From: Lorrie J. LeLe
To: [Harris, Susan](#)
Cc: [Kyle C. Jones](#)
Subject: Comments on Draft EIR - Boulder Brush Facilities (4646)
Date: Monday, February 03, 2020 4:07:30 PM
Attachments: [4646-013j - ABJC DEIR Comment to SD County.pdf](#)

Please find attached comments submitted on behalf of Citizens for Responsible Wind Energy and Doyle Mills on the Boulder Brush Facilities Draft Environmental Impact Report.

We are writing on behalf of Citizens for Responsible Wind Energy and Doyle Mills to provide comments on the December 12, 2019 Draft Environmental Impact Report ("DEIR") prepared by DUDEK for the County of San Diego ("County"), pursuant to the California Environmental Quality Act ("CEQA"),¹ for the Boulder Brush Facilities, which include a lease agreement between the Campo Band of Diegueño and Terra-Gen Development Company LLC ("Campo Lease") for the Campo Wind Project ("Project").² The DEIR incorporates by reference a May 2019 Draft Environmental Impact Statement ("DEIS") prepared by the Bureau of Indian Affairs ("BIA"), pursuant to the National Environmental Policy Act. ("NEPA").

Figure 1. Turbine strings removed in Project Alternative 2.

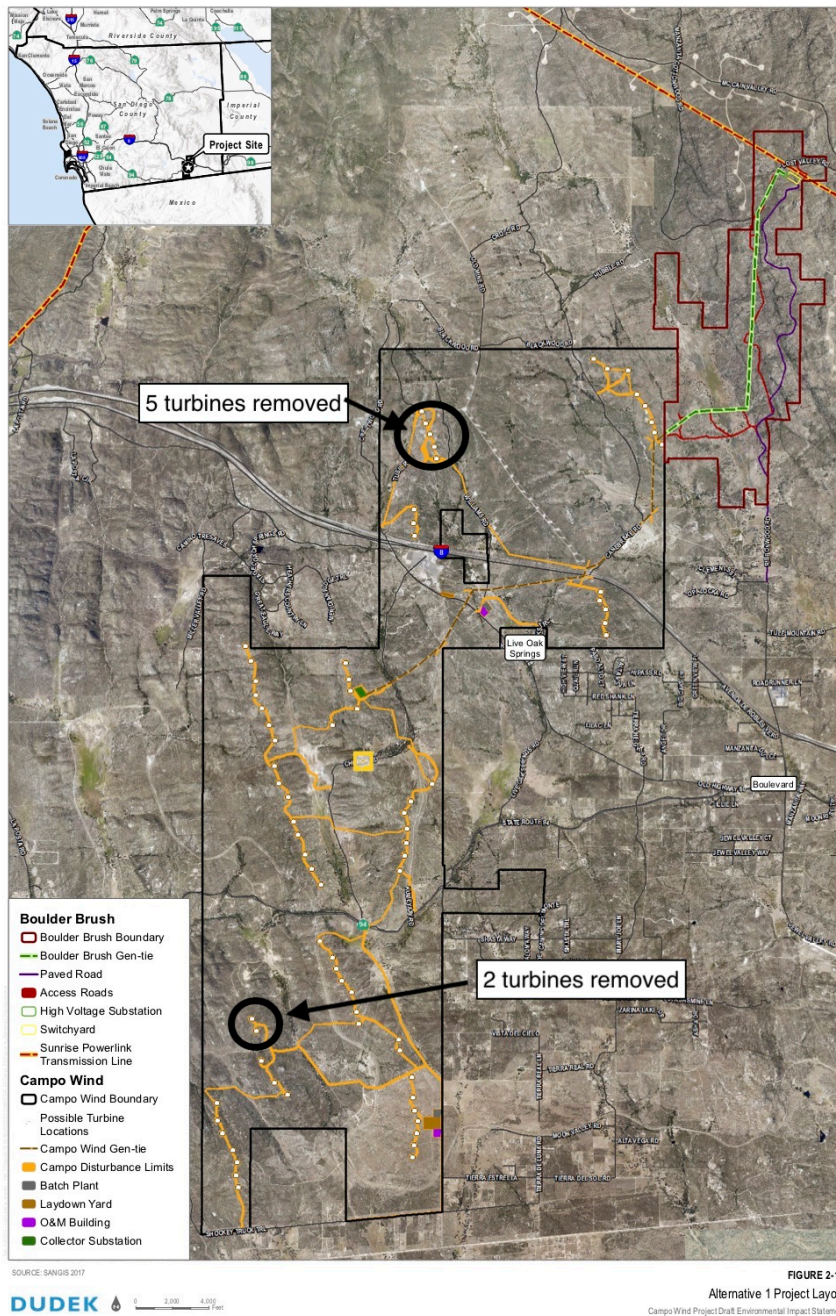
would have less turbines than proposed under Alternative 1).⁴² Figure 1 (below) depicts the two turbine strings that would be removed under Alternative 2.

Figure 2. April 10, 2019, record of Dudek detecting Quino checkerspot butterflies on Boulder Brush portion of the Project site.

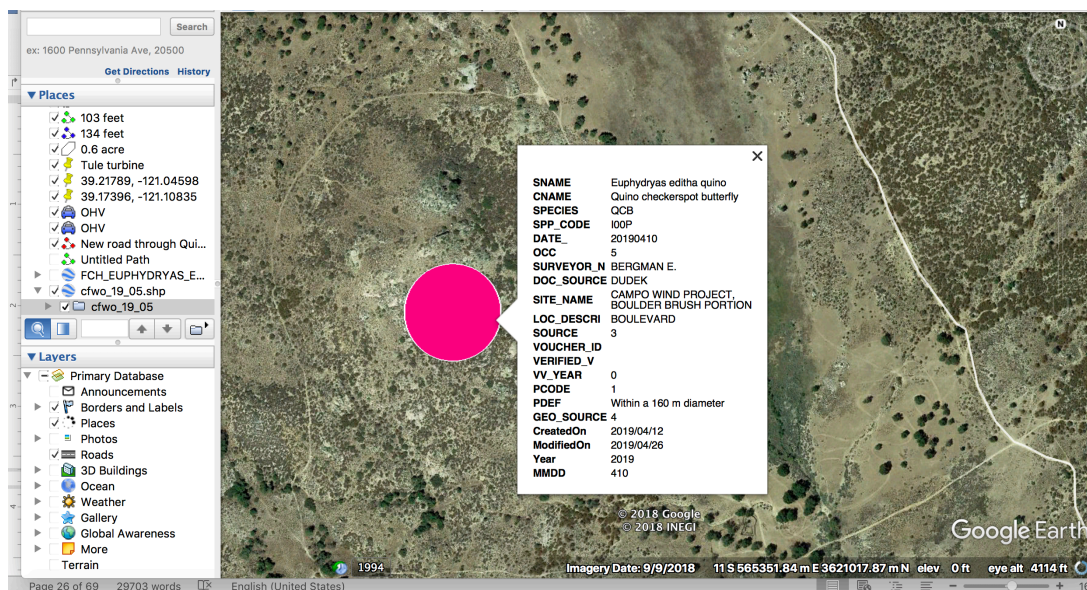
Furthermore, Dudek detected five Quino checkerspot butterflies in the Boulder Brush Corridor on April 10, 2019—six weeks prior to release of the DEIS and BTR (Figure 2, below).⁹⁴ *This information was not disclosed in the DEIS or BTR*, and it is critical to assessing the Project's impact on recovery of the subspecies. Specifically, the Recovery Plan for the Quino

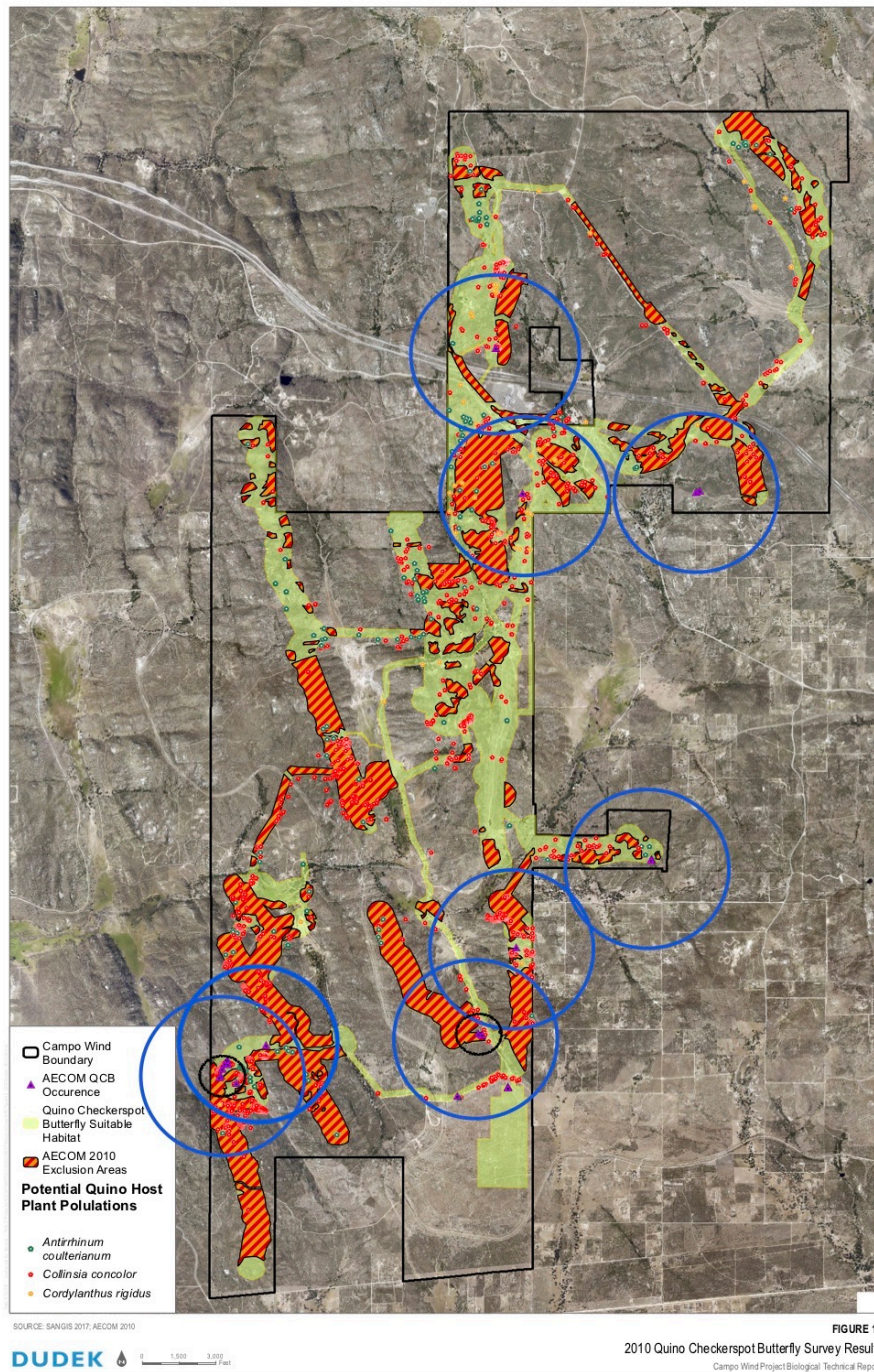
As the focused adult surveys ensued, some surveyors observed patches of open habitat in the dense chaparral they deemed suitable for the species. Starting in survey week 2, Quino observations were made outside of the original survey area (Figure 3). The survey area was expanded during survey week 2 to include additional trails and narrow openings in the chaparral that were not easily visible during habitat assessments. The expanded survey area is depicted in Figure 3 and constitutes approximately 541 additional acres.¹¹²

Figure 7. Landscape before (top image) and after (bottom image) construction of the Kumeyaay Wind Farm. Damage caused by off-road vehicle travel to turbine is evident in bottom image. For comparison, black circle depicts same rock feature in both images.

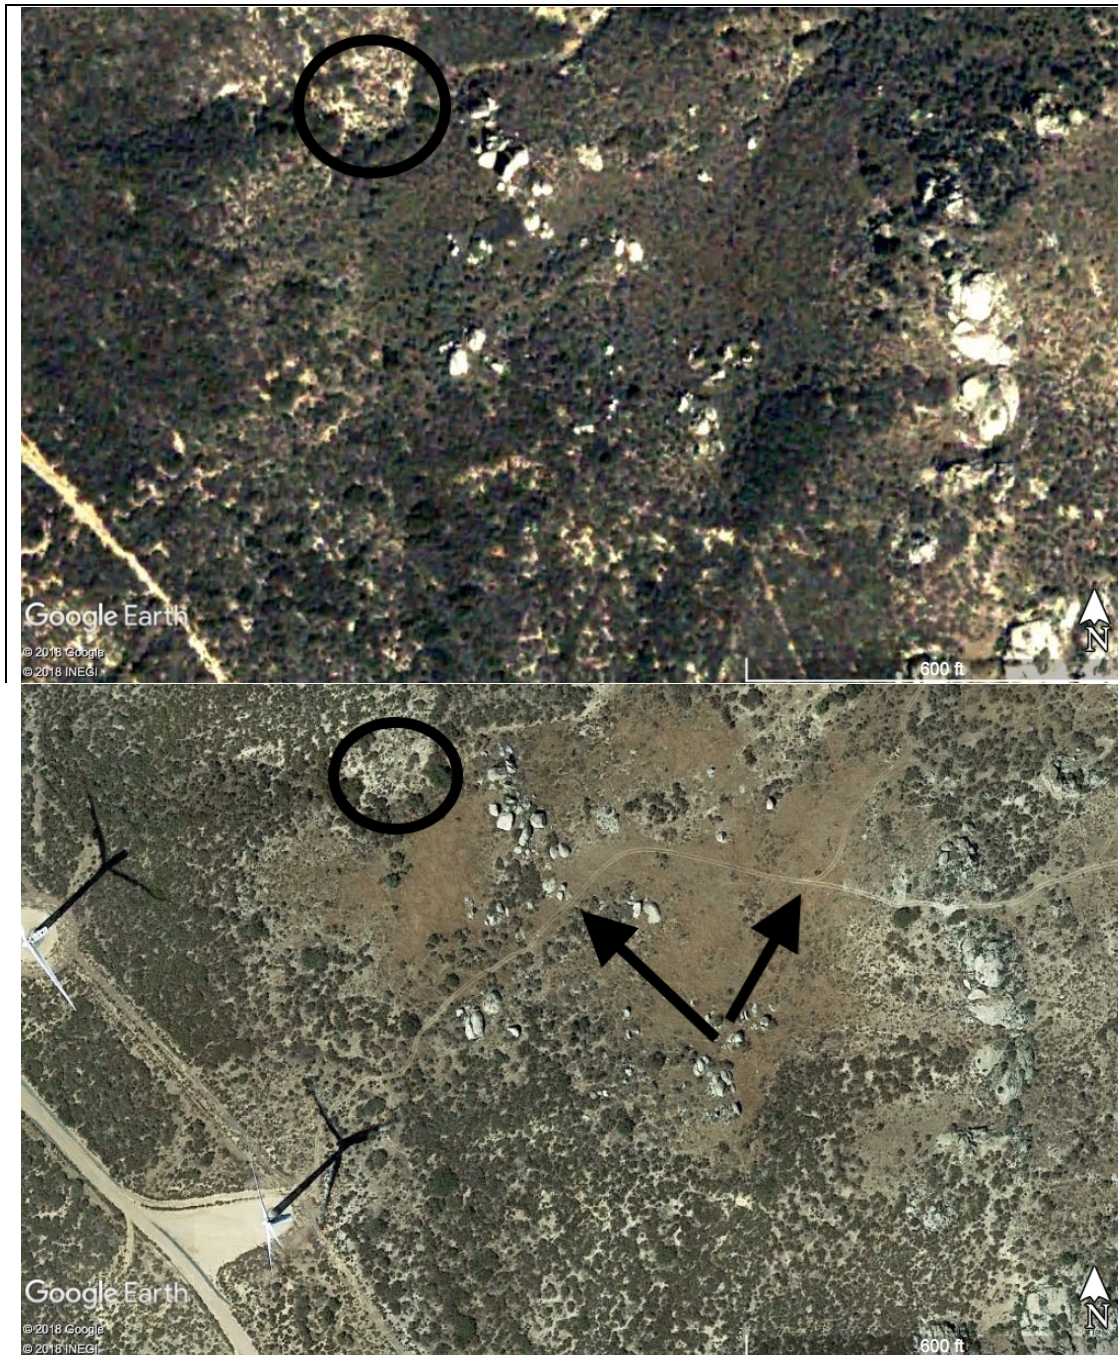
- The invasive weed problem is not limited to “planting any invasive species.”
- The BTR fails to provide effects determinations for increased human use and trampling of vegetation.¹⁶² Because the DEIS does not provide any additional analysis beyond what is provided in the BTR, it does not have the basis for concluding those effects would not be adverse. Google Earth imagery provides evidence of damage to vegetation caused by off-road vehicles traveling to and from the Kumeyaay Wind turbines after they were installed (Figures 7 through 9, below).

Figure 10. Project features in relation to Quino checkerspot butterfly occurrence records (colored circles). Turbines and roads are not to scale (disturbance will be more extensive than depicted). Extensive construction will occur in an area with high concentration of butterfly occurrences.

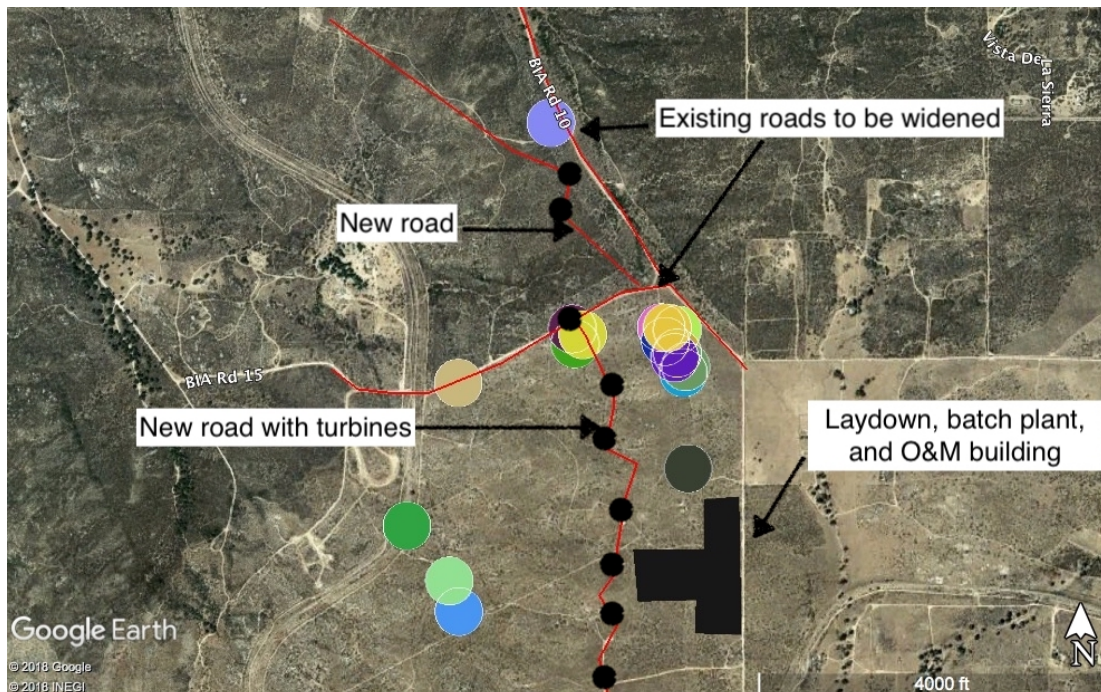
The DEIS fails to provide any evidence that the BIA has sought assistance from the USFWS or otherwise attempted to develop a Project alternative that would avoid and minimize Project impacts to the Quino checkerspot butterfly (and its habitat) to the maximum practicable extent. Indeed, both Alternative 1 and Alternative 2 include Project features in the portion of the Project site containing the highest concentration of Quino checkerspot butterfly occurrences (Figure 10, below).

Figure 1. Essential Connectivity Area within the Project site.¹⁰⁴

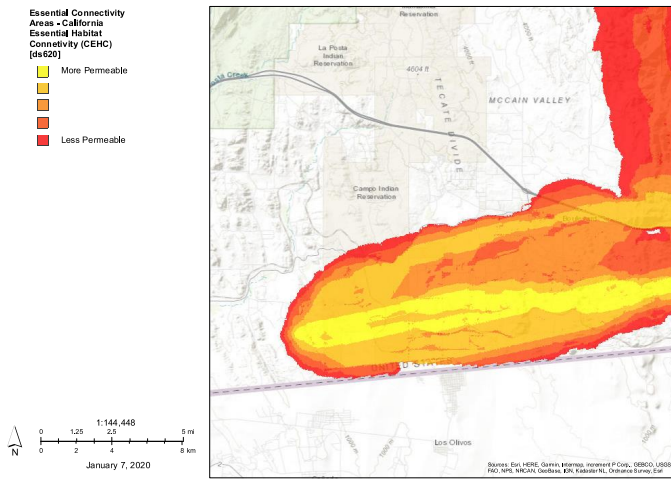
The DEIR states: “[t]he Boulder Brush Corridor and Campo Corridor are not readily identifiable as corridors per se, because wildlife movement is not constrained or directed through the Project Site. The Boulder Brush Corridor is, however, included within a Core Wildlife Area due to its size and the undeveloped land in the surrounding area (County of San Diego 2010a).”¹⁰² This is incorrect; a portion of the Campo Corridor has been classified an “Essential Connectivity Area” because it provides areas essential for ecological connectivity between large, relatively natural habitat blocks that support native biodiversity (Figure 1, below).¹⁰³

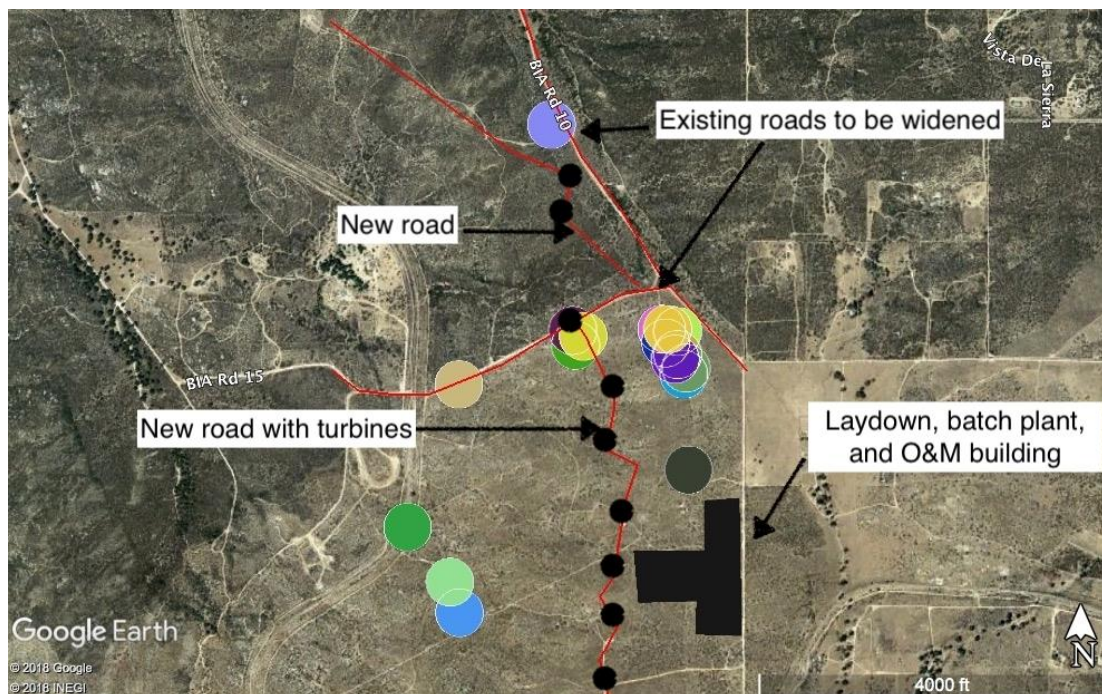
of the Project site containing the highest concentration of Quino checkerspot butterfly occurrences (Figure 3, below).

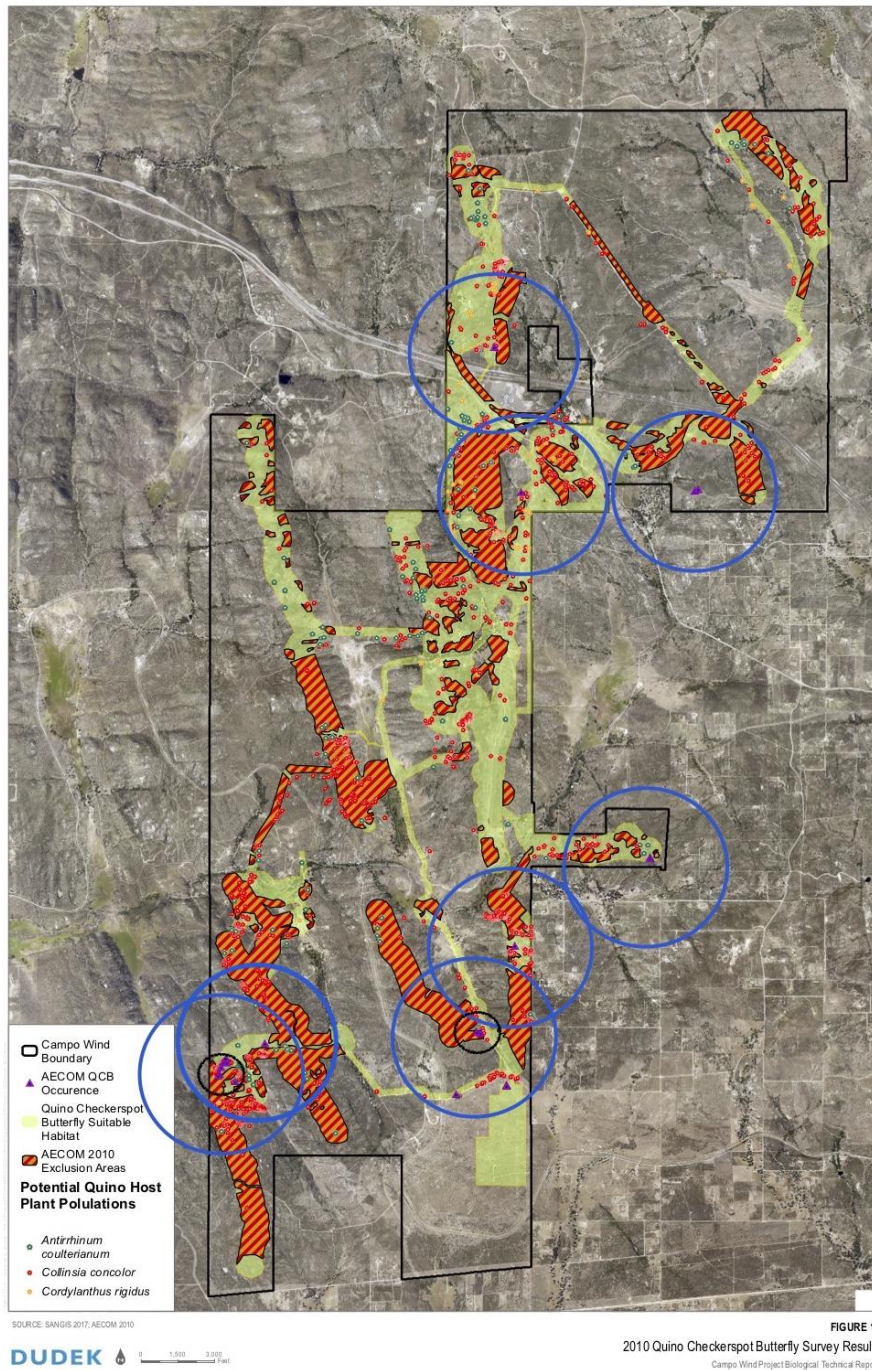
As the focused adult surveys ensued, some surveyors observed patches of open habitat in the dense chaparral they deemed suitable for the species. Starting in survey week 2, Quino observations were made outside of the original survey area (Figure 3). The survey area was expanded during survey week 2 to include additional trails and narrow openings in the chaparral that were not easily visible during habitat assessments. The expanded survey area is depicted in Figure 3 and constitutes approximately 541 additional acres.¹³⁵
